SNUPPS

Standardized Nuclear Unit
Power Plant System

April 17, 1984

SLNRC 84-0069 FILE: 0278
SUBJ: Revision in Diesel Generator
Start Time

FIGURE 15.6-4.10
DECLG (C_D=0.6)
CORE INLET VELOCITY
DURING REFLOOD

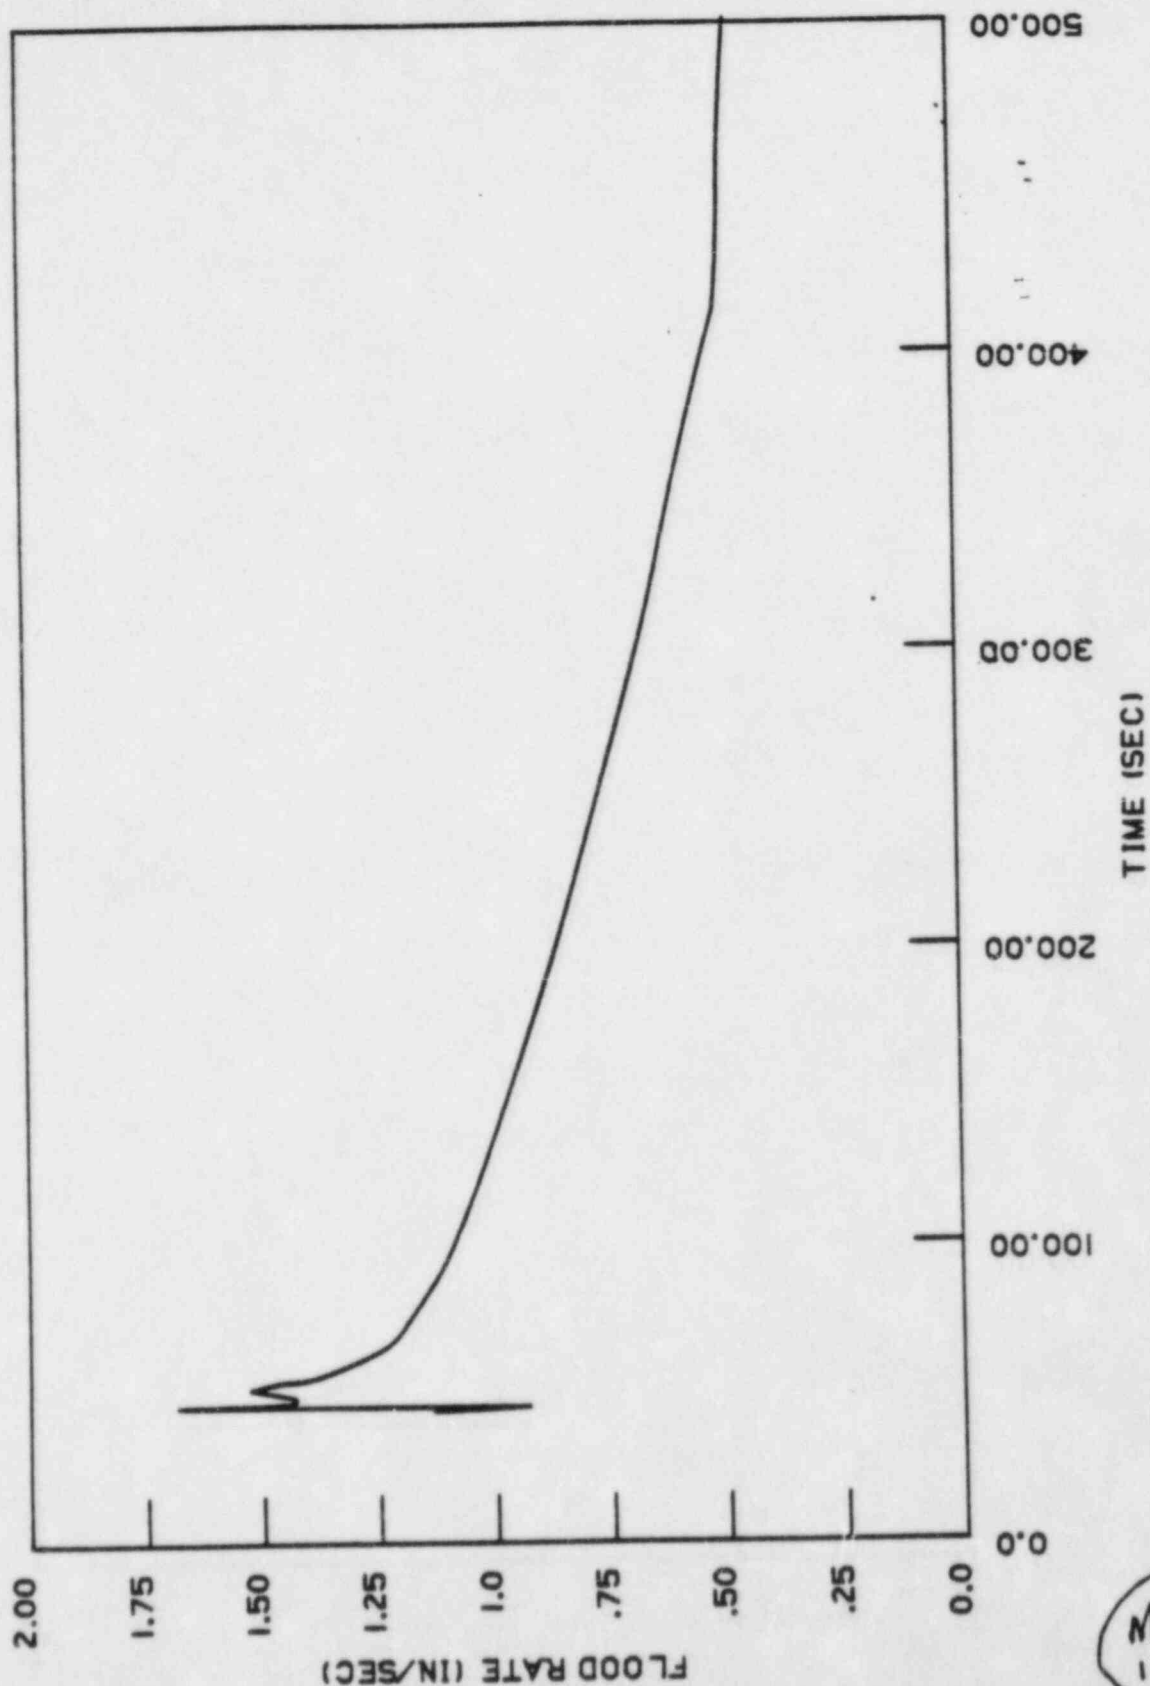
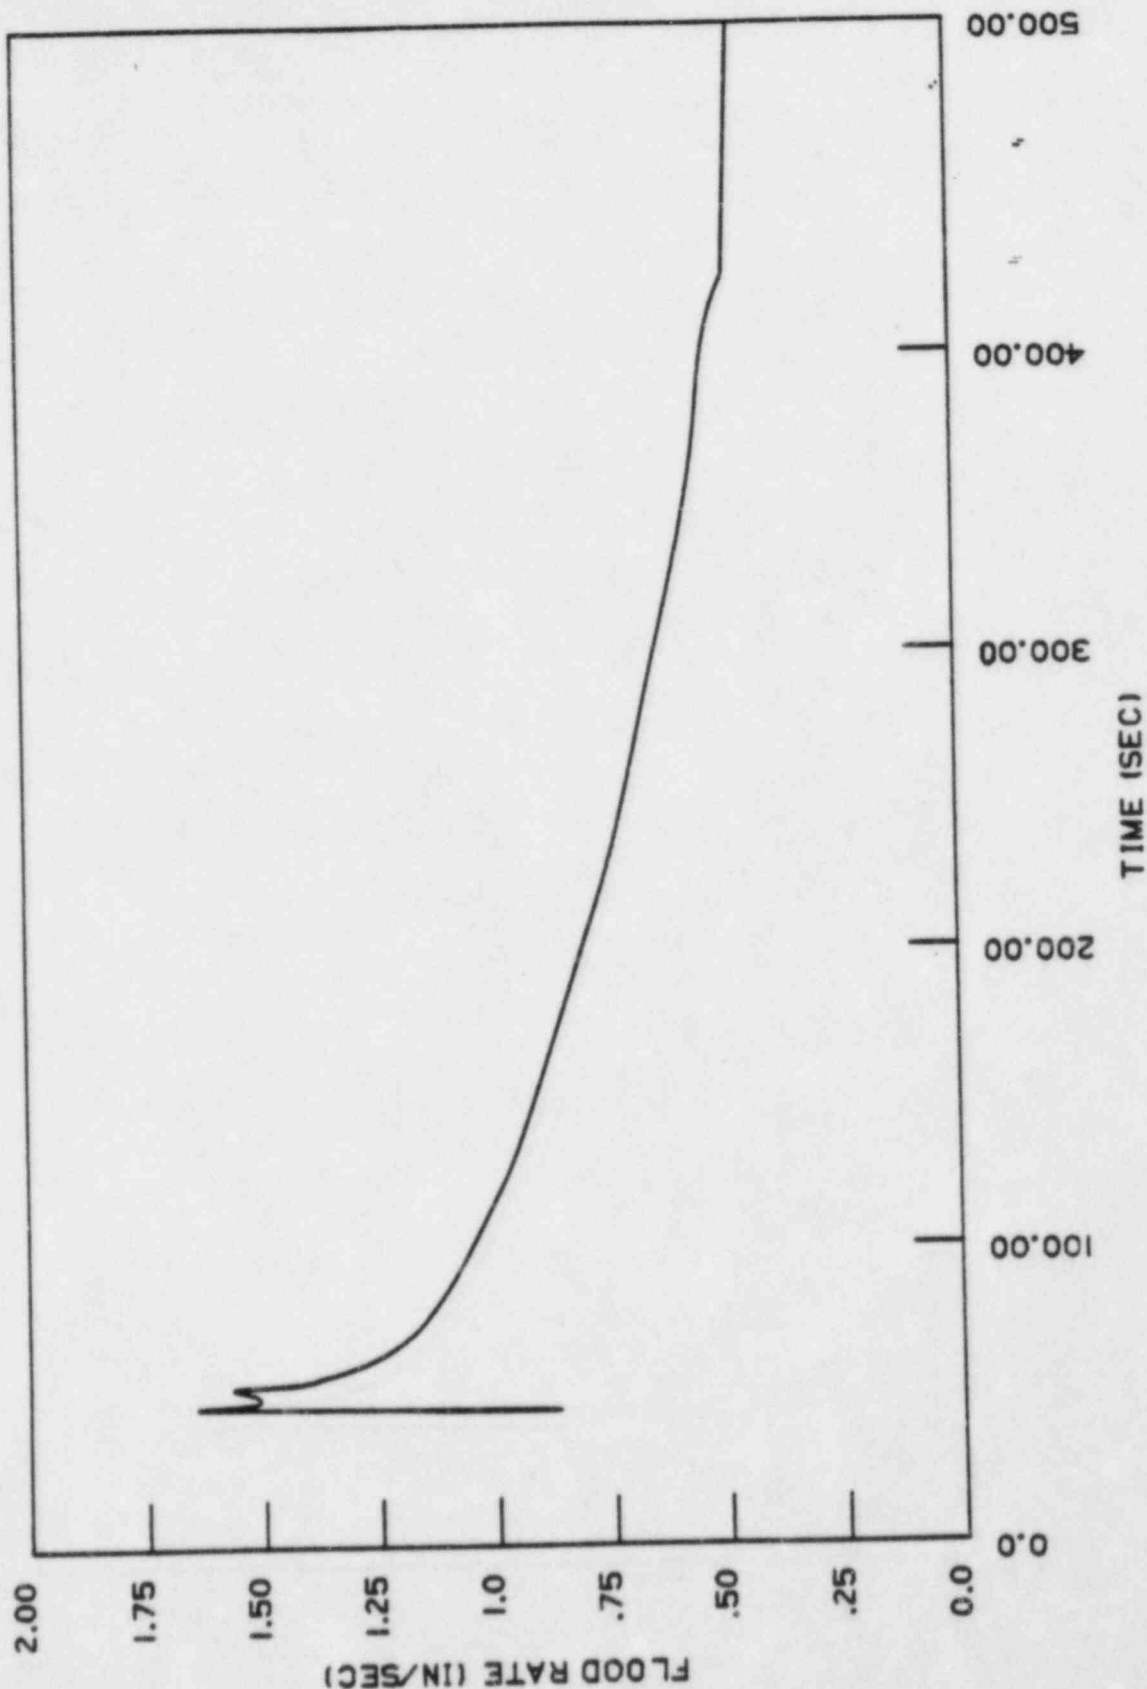
12 SEC D/G
START

FIGURE 15.6 - 10a
DECLG ($C_D = 0.6$ MAX SI)
CORE INLET VELOCITY
DURING REFLOOD

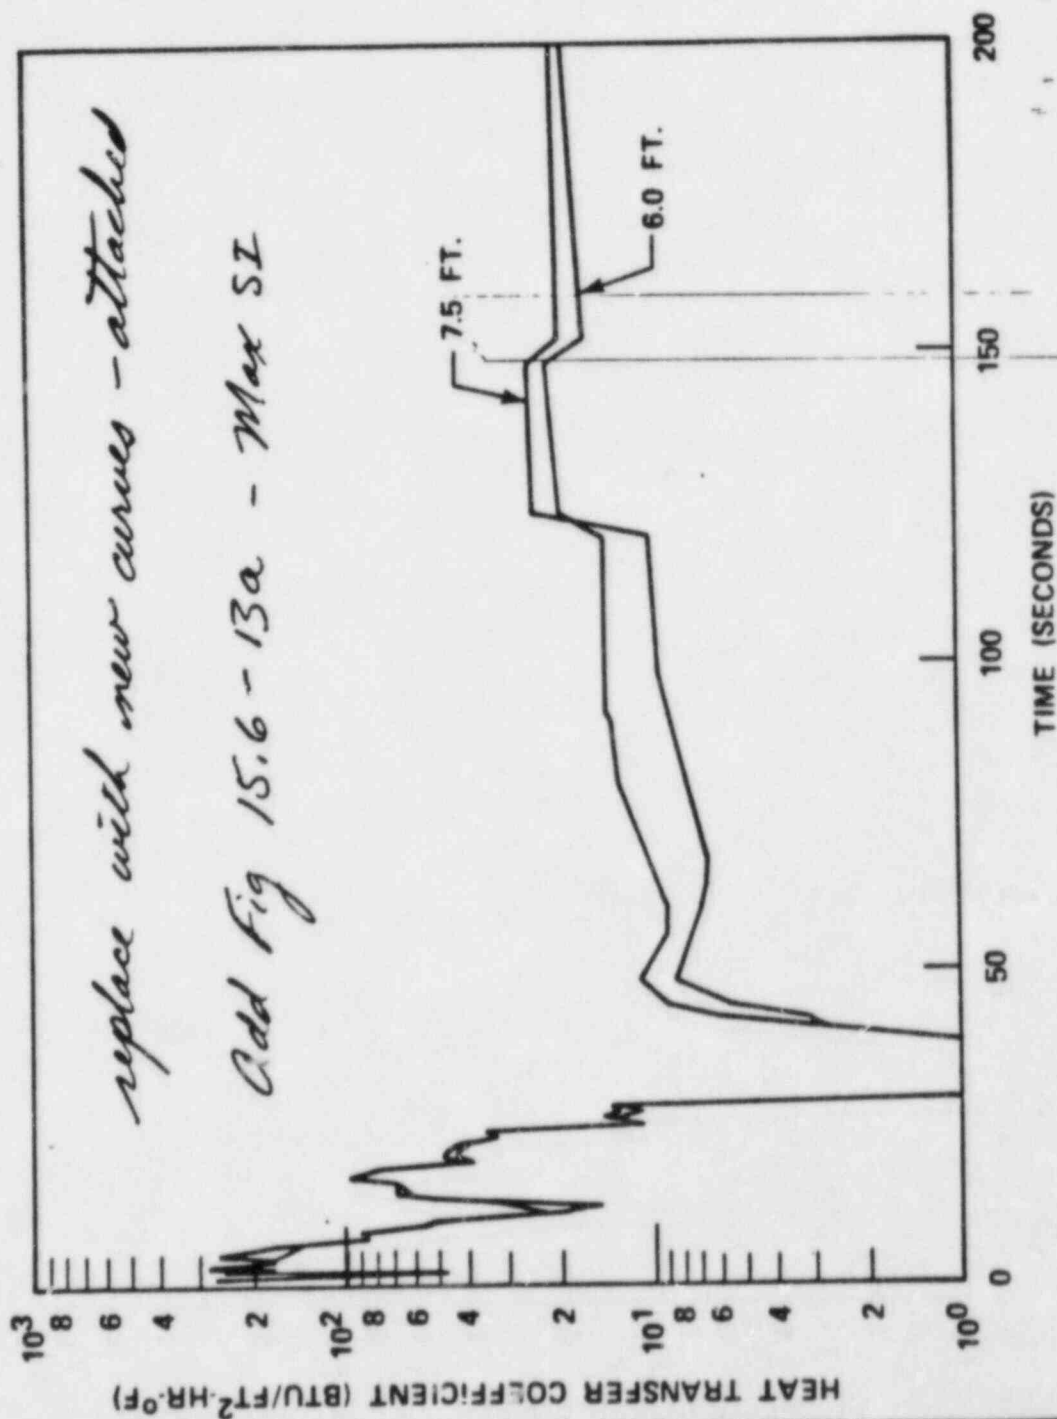
The worst break in the spectrum of break sizes analyzed was a discharge coefficient (C_d) of 0.6. This worst break was analyzed with a 12 second diesel generator start time, to study the effect of a 2 second delay in the start of the diesel generator. Two cases are presented in Table 15.6-11 for the $C_d = 0.6$ DECLG break: The minimum safety injection case and the maximum safety injection case (Reference 27 methodology). The maximum safety injection case proved to be the most limiting.

SNUPPS
FIGURE 15.6-13
CORE HEAT TRANSFER
COEFFICIENT
DECLG ($C_D=0.6$)

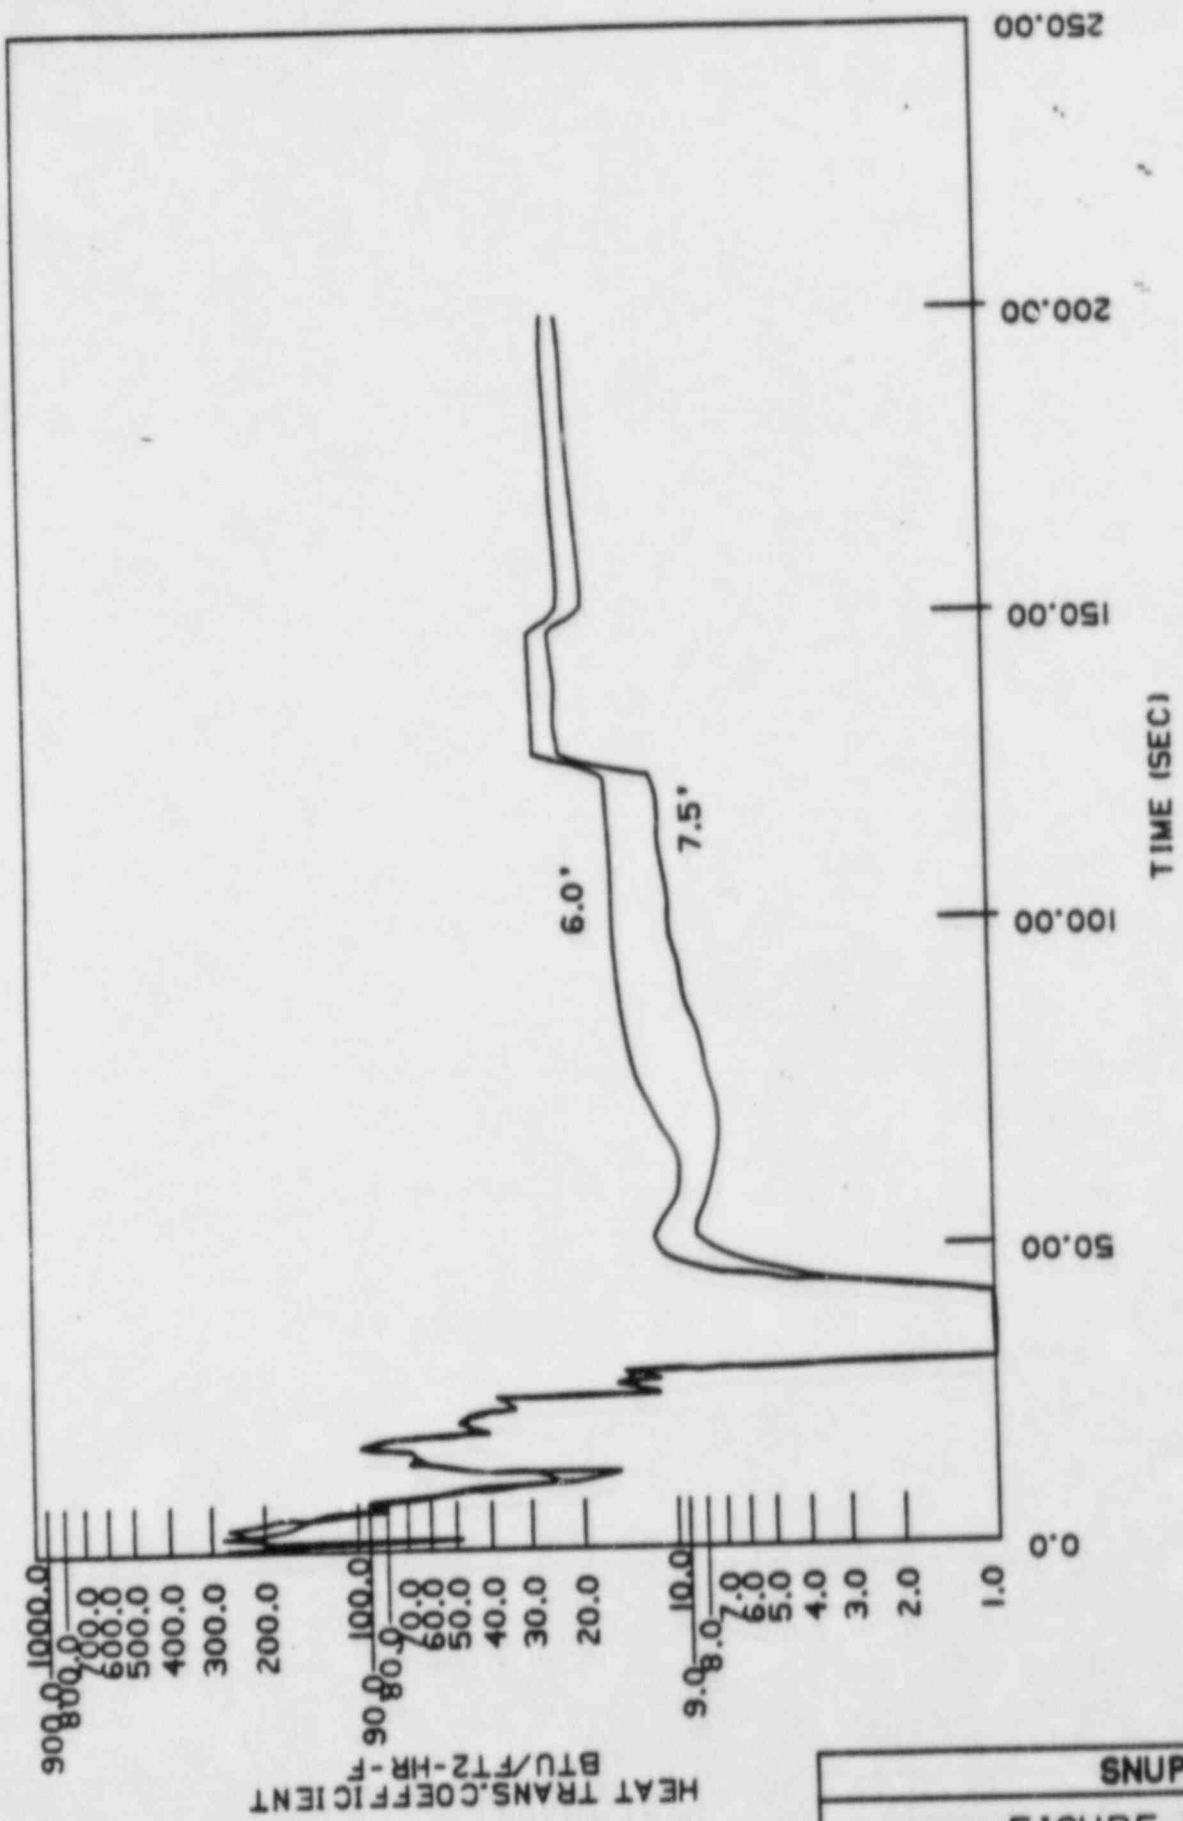
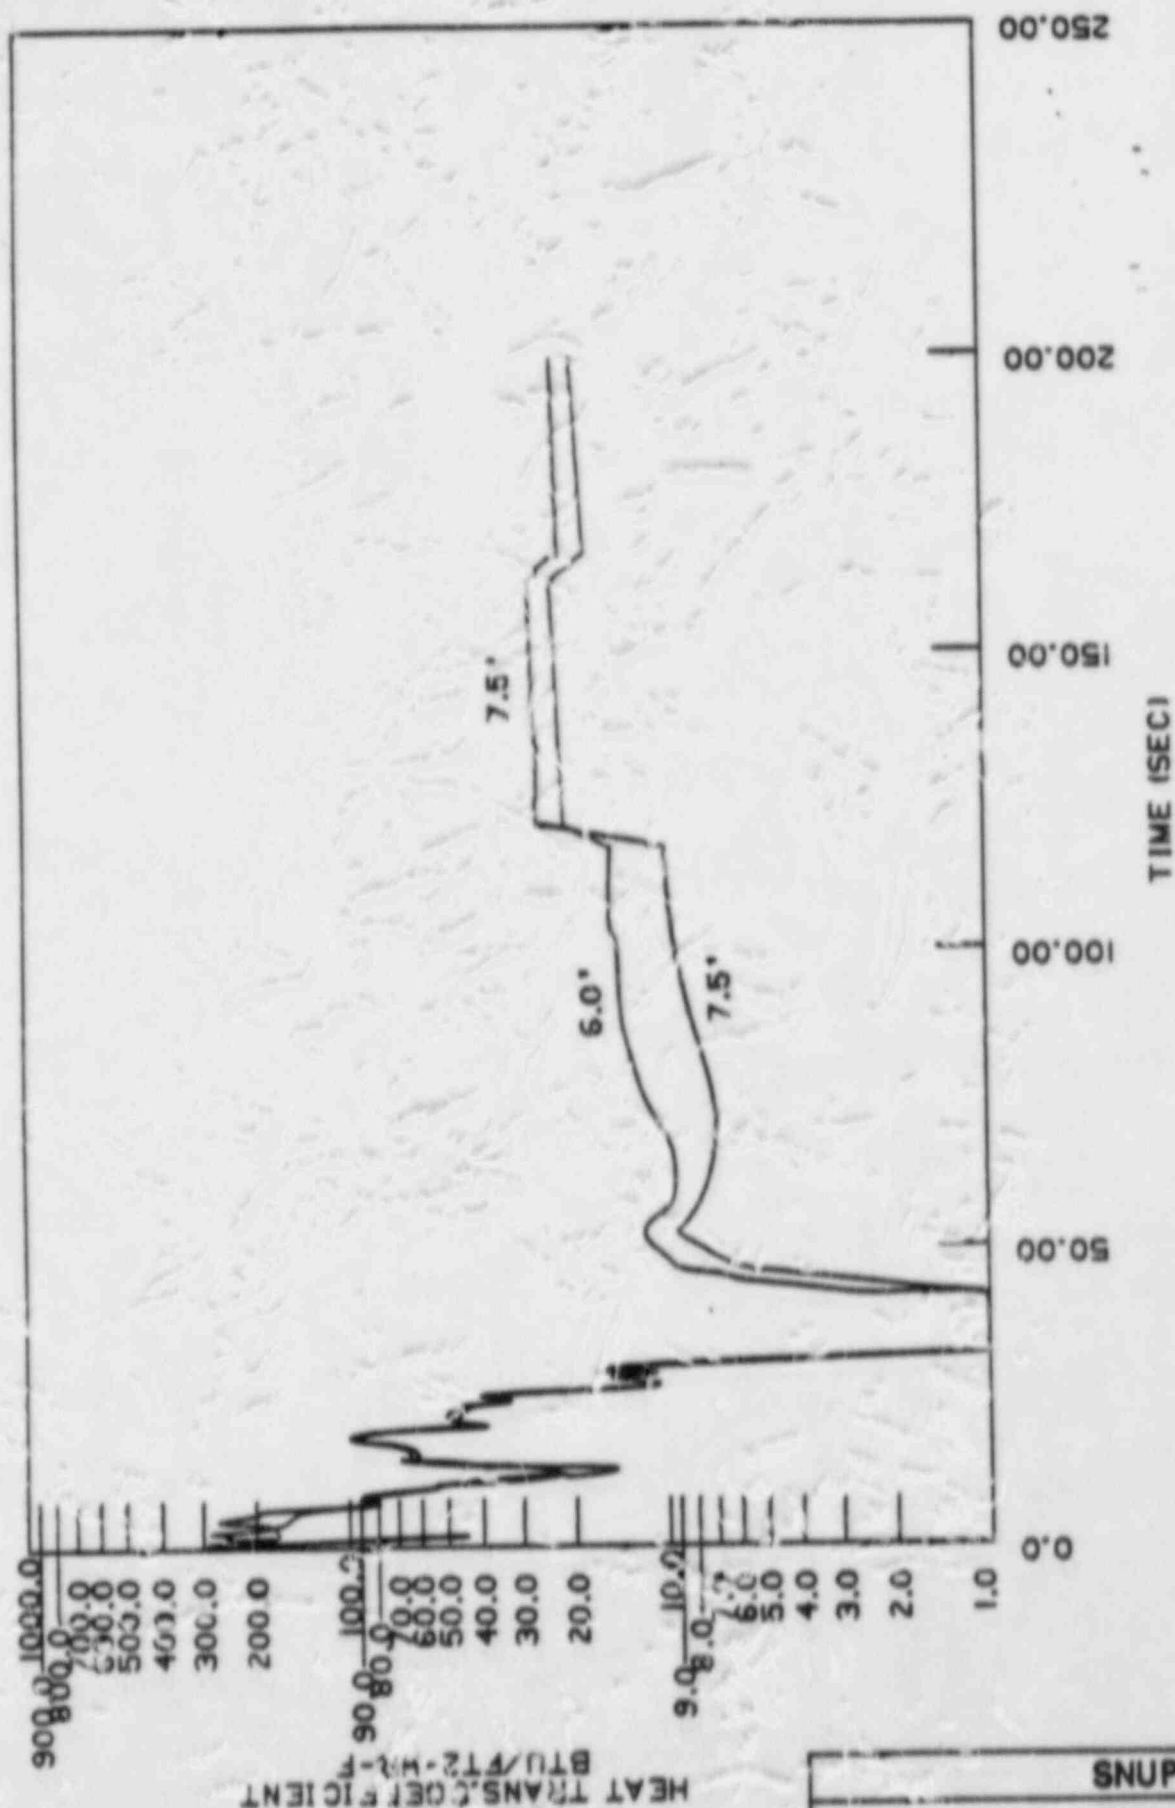
12 SEC
D/G STAG
